Addendum #1
ITB # 23-20, Stainless Steel Manhole Inserts
02/11/2020

NOTICE IS HEREBY GIVEN that the following addendum serves to provide clarification and to answer the questions received on ITB #23-20, Stainless Steel Manhole Inserts.

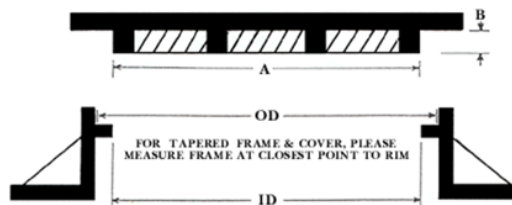
Question 4: When the solicitation asks for the following dimensions: 22", 23", 22.5", is it referring to the inner diameter (ID) or the outer diameter (OD) for the inserts?

Answer to Question 4: In the Diagram below, the dimensions requested in this solicitation would be the OD (outer diameter). The sizes are measured from the outside edge to the outside edge of the lip as measured across the center of the rain tray.

Exhibit A- City of Clearwater Standard Manhole Ring and Cover

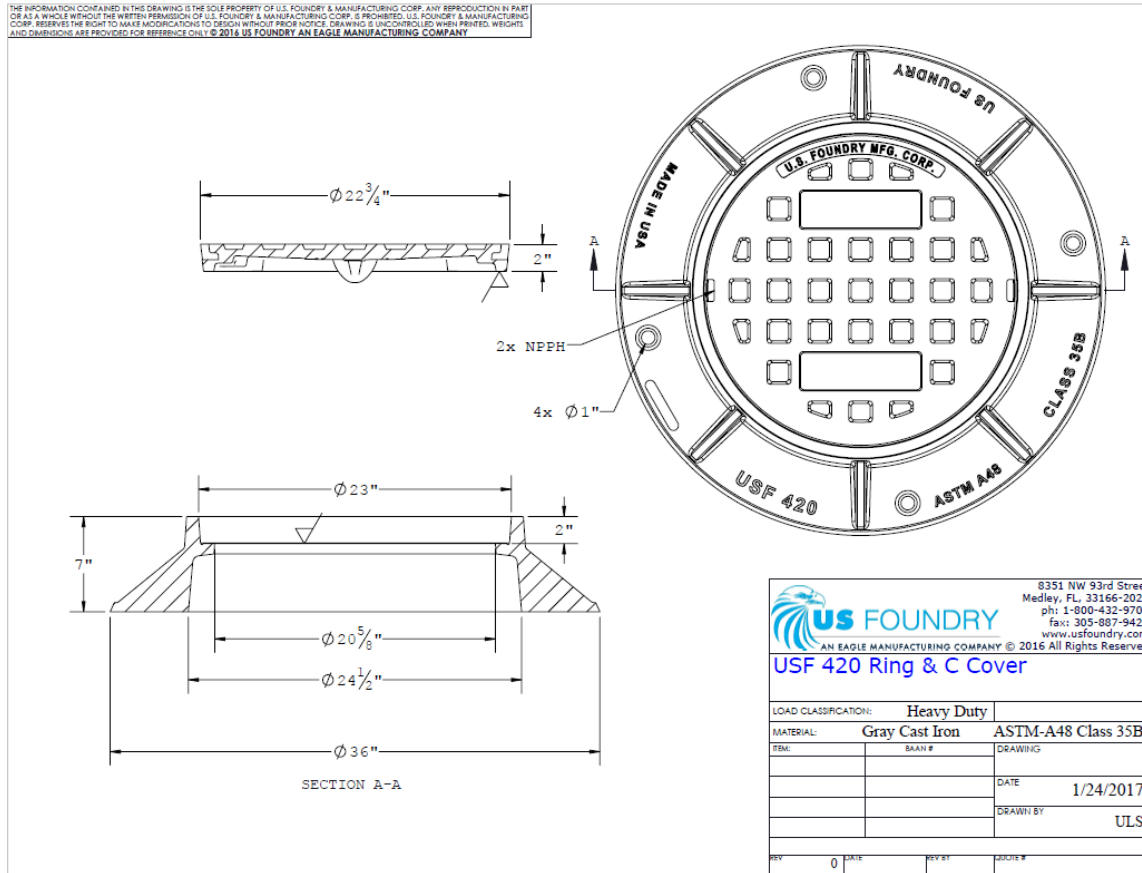
Question 5: What are these measurements of: Manhole lid OD? ID?

Answer to Question 5: An example of our standard manhole ring and cover can be found on page three (3) of the addendum, Exhibit A- USF 420 Ring & C Cover.
